LOWER MINNESOTA RIVER WATERSHED DISTRICT

Lower Minnesota River Watershed District Board of Managers Meeting

Item 6. J. – Permits & Project Reviews

Re: County State Aid Highway (CSAH) 61 Drainage Ditch Improvements
(LMRWD No. 2021-002)

Figure 1: CSAH 61 Drainage Ditch Improvements

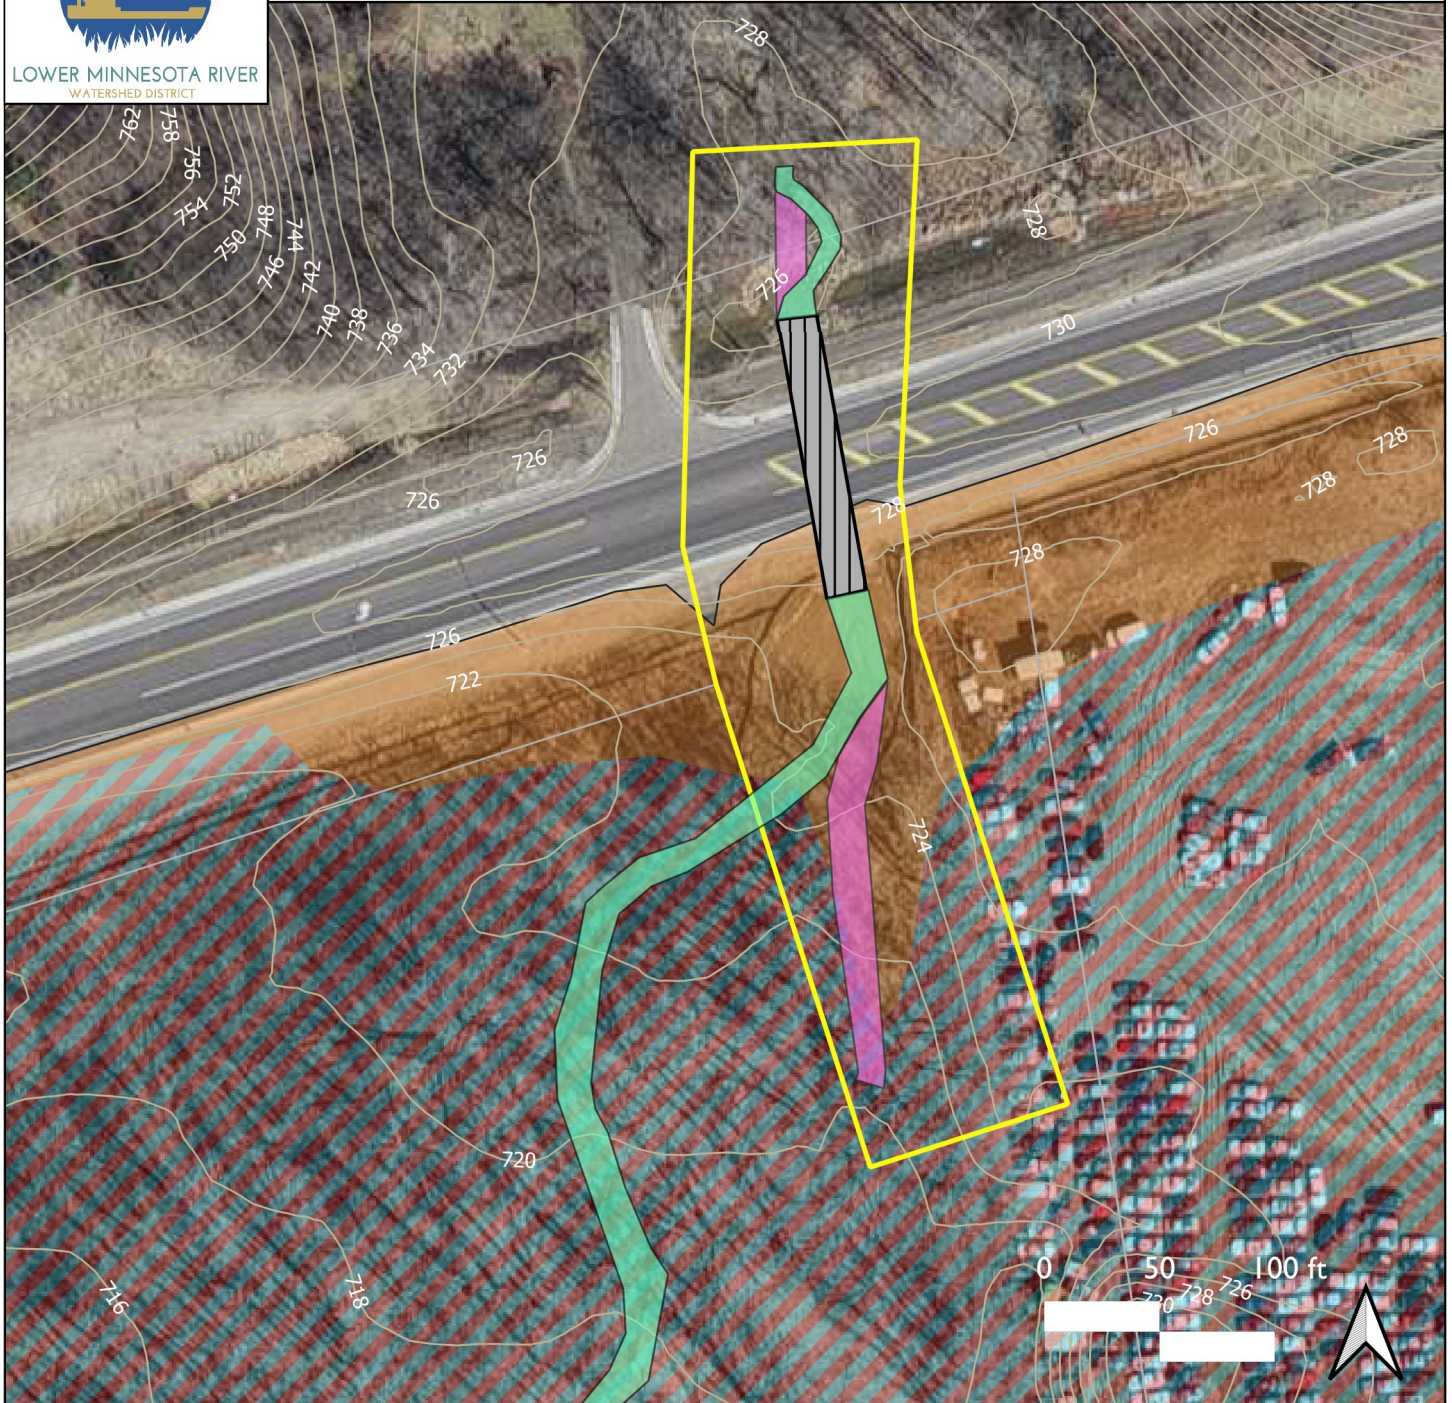
The Project proposes excavating a new channel and stilling basin within County right-of-way and south of TH 101 to improve the channel hydraulics, prevent sediment buildup in the culvert, and prevent the continued westerly migration of the creek onto USFWS property. On the north side of CSAH 61, the Project proposes to straighten the drainageway as it enters the culvert. The 100-year floodplain is located only on the south side of CSAH 61, so the channel straightening and associated fill will not affect high water elevations on the Minnesota River. The County has provided hydraulic calculations demonstrating the new channel cross-section has the capacity to convey the flows as designed.

As part of the LMRWD 2020 Gully Inventory and Condition Assessment, the CSAH 61 culvert was surveyed and clearly presented with excessive sedimentation and evidence of the need for this project (Gully L199 Assessment). However, the Project is unlikely to solve the sedimentation problem at this location. The CSAH 61 culvert serves a 400-acre upstream watershed that includes High Priority Region 11 (Figure 2). The stream reach between High Priority Region 11 and CSAH 61 (Gully L197 Assessment) shows the extent of bank erosion and channel degradation occurring immediately upstream of the proposed project. Until this reach and the upstream High Priority Region are stabilized, the County is likely to continue to face sediment maintenance problems.

The staff recommends approval of the CSAH 61 Drainage Ditch Improvements Project. A follow-up meeting with the County and Cities of Chanhassen and Eden Prairie is recommended to discuss potential opportunities to address the larger erosion issue occurring upstream.

Figure 1: Hwy 13 & Lone Oak Signal Project Location

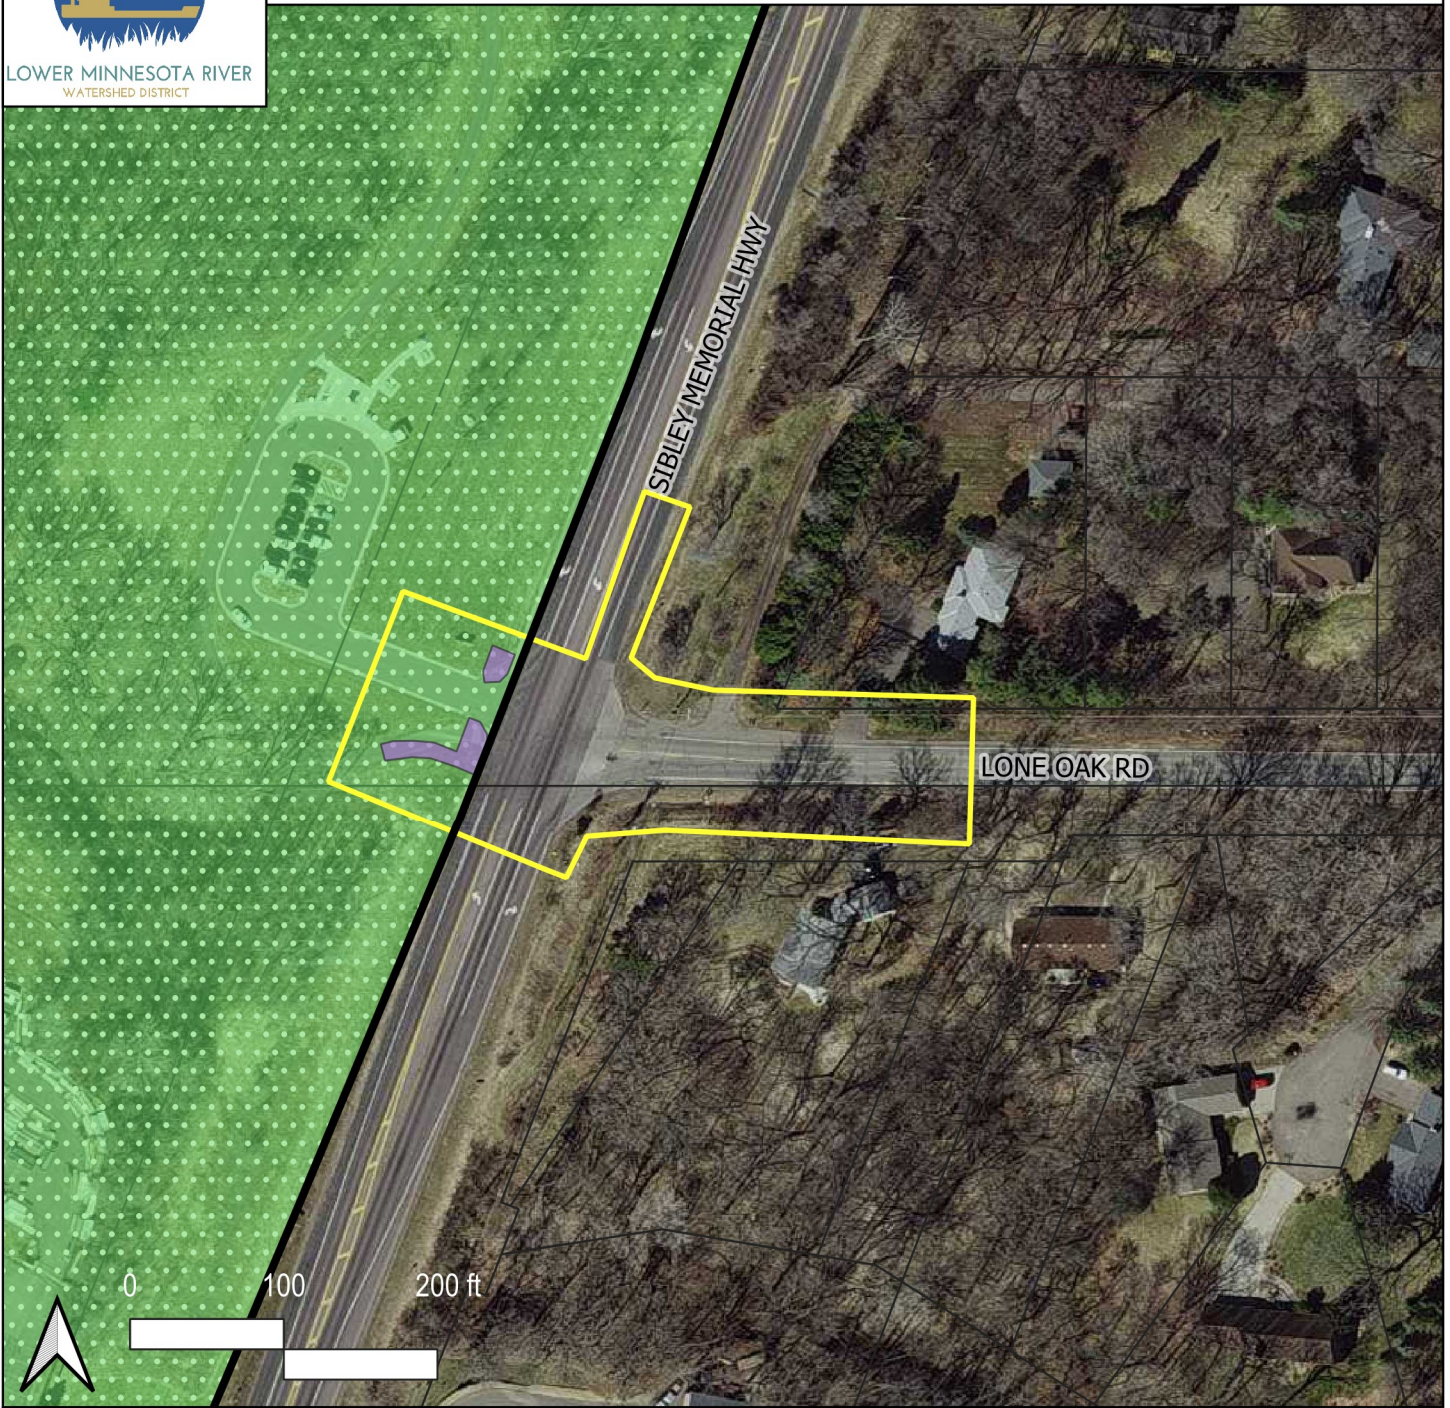
The District regulates land-disturbing activities that involve the excavation of 50 cubic yards or more within the HVRA. The HVRA occurs on the west side of Trunk Highway (TH) 13. The Earthwork Tabulation sheet shows 180 cubic yards will be excavated for TH 13. The applicant has provided an erosion and sediment control plan and a Stormwater Pollution Prevention Plan. The proposed grading does not substantially change the existing topography or drainage patterns, and because the Project disturbs less than one acre, a copy of the NPDES permit is not needed. The Project complies with Rule B.

Figure 1: Burnsville Cemetery Project Location

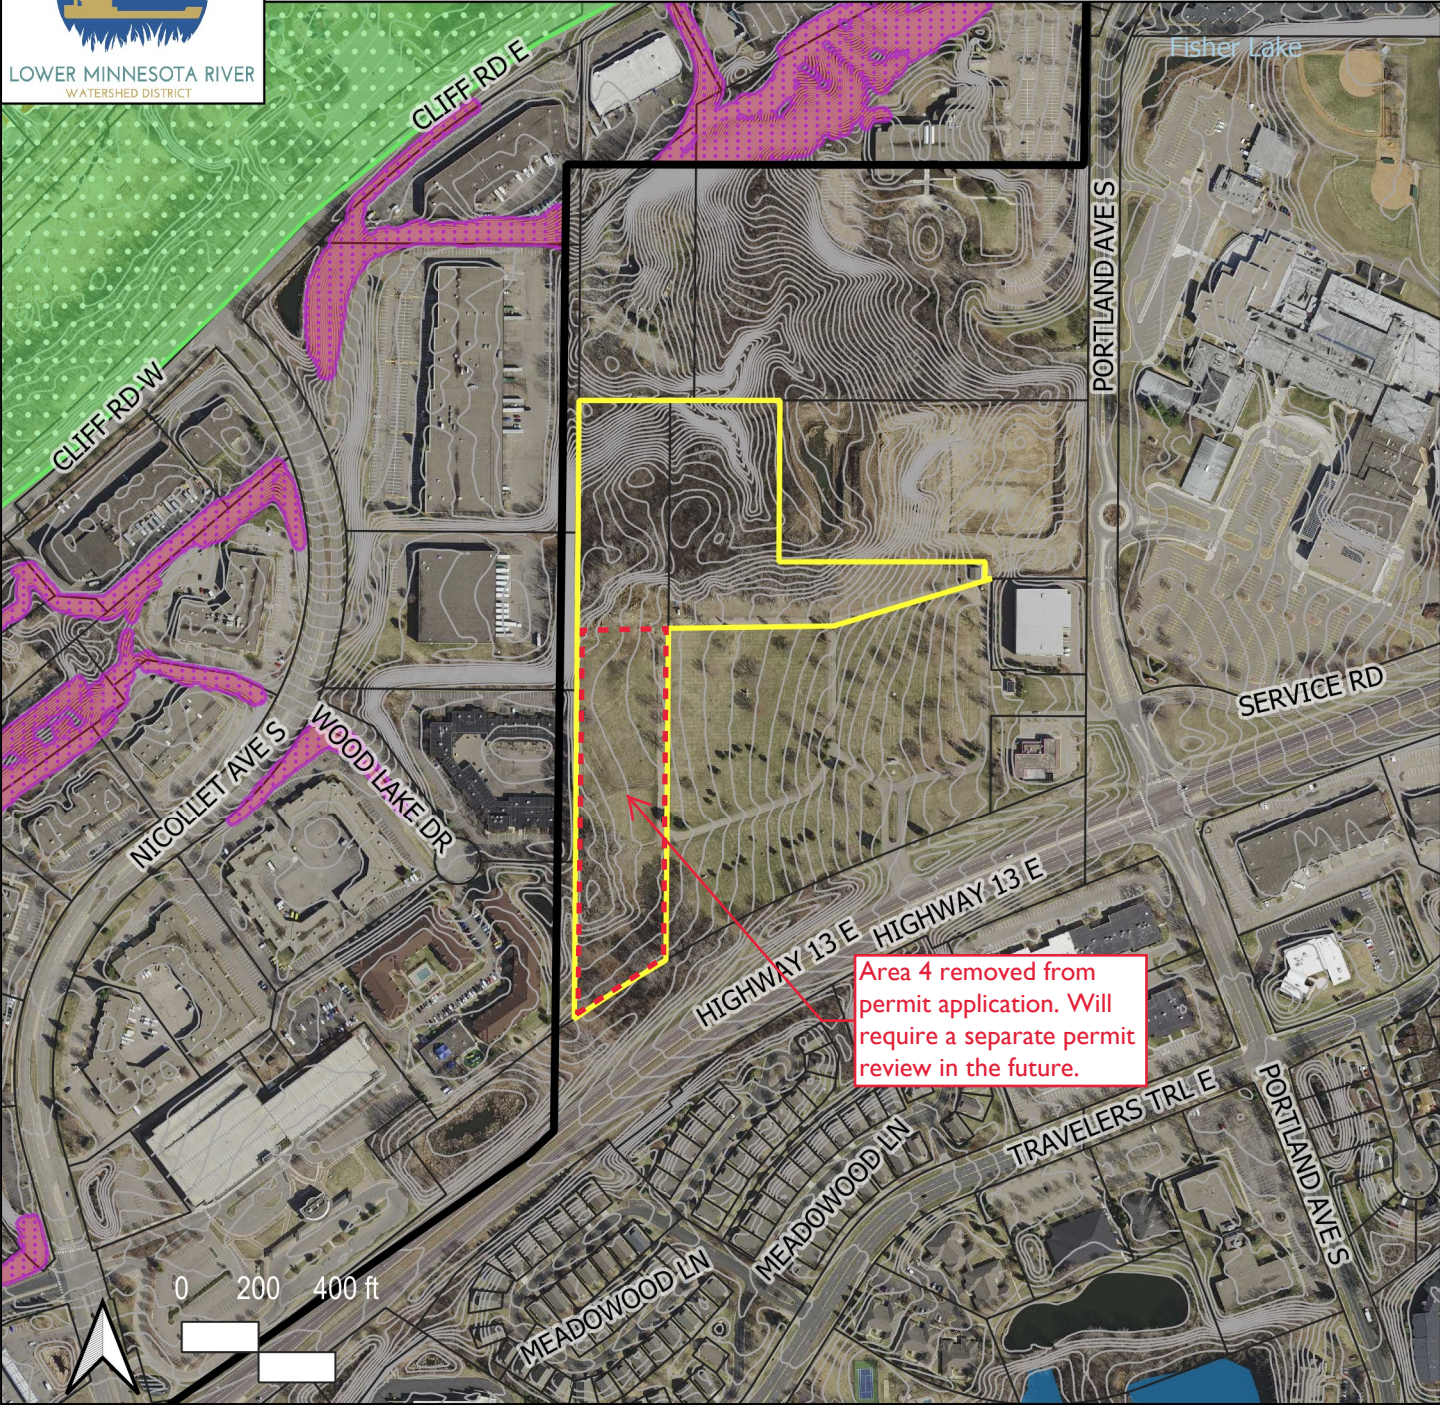
Additionally, the Project has received a public comment regarding stormwater draining onto neighboring properties. The area in question is within the Project's delineated Drainage Area 4 in the southwest corner of the site. The applicant sent an email to LMRWD on September 17, 2021, stating the southwest drainage area grading will be left alone until they can work with the Minnesota Department of Transportation to mitigate Highway 13 drainage ditch overflow that comes into the area to avoid upsetting the neighbors. This review will not incorporate the area of Drainage Area 4, so a separate permit for this area may be needed in the future.
